AS BUILT
DEC 6, 1994

JEFFERSON COUNTY
LAW ENFORCEMENT CENTER
JEFFERSON, WISCONSIN

1/16"-1'-0" SCALE
FLOOR PLANS
FIRE ALARM

10-11-90
E-17

GROUND FLOOR PLAN

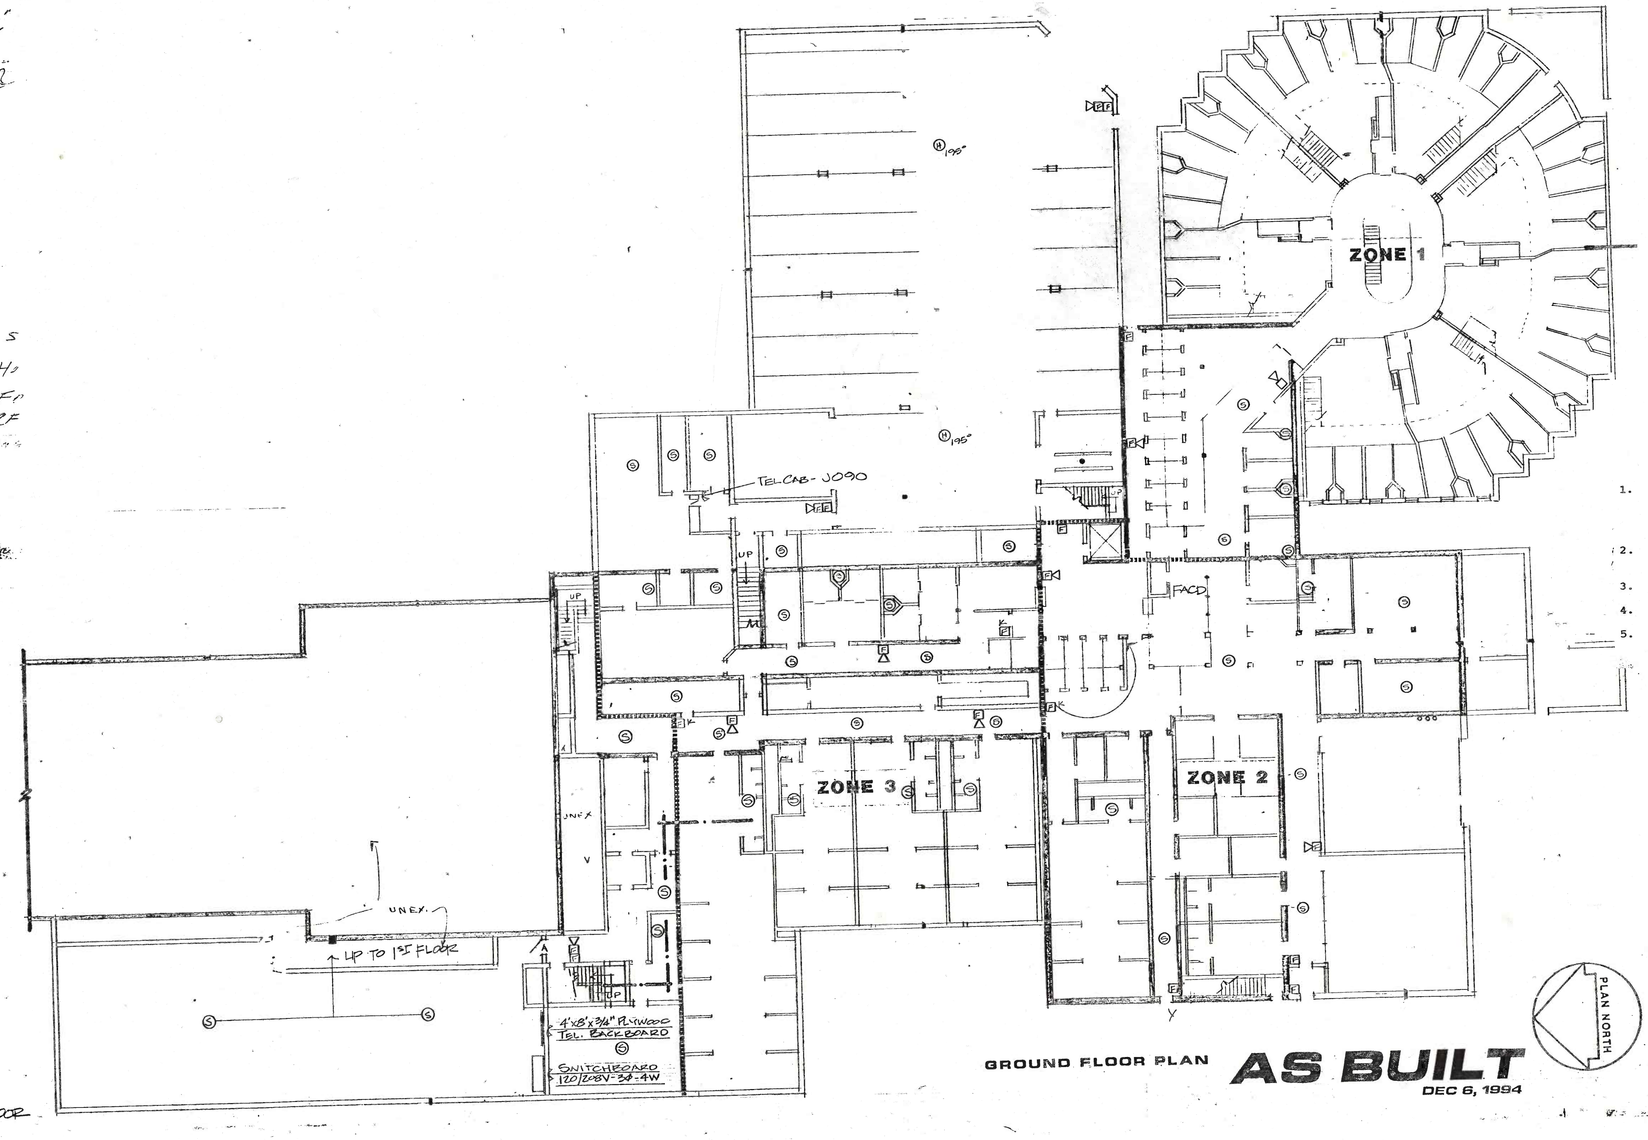
DATE	REVISION
	1. Add 2 smoke detectors in mechanical room over kitchen. Add 1 smoke detector in dispatch Room S1047. Add 1 smoke detector in J060. Add 3 smoke detectors in storage room adjacent to Room J060.
	2. Delete fire alarm control panel in S1047. Add fire alarm control panel in Room J023.
	3. Delete smoke door holders in Rooms C1113 and C2030.
	4. Relocate switchboard in Generator Room to North wall.
	5. Relocate switchboard and communication equipment to East wall of Room J062 starting 16' 0" off wall between Rooms J062 and J060.
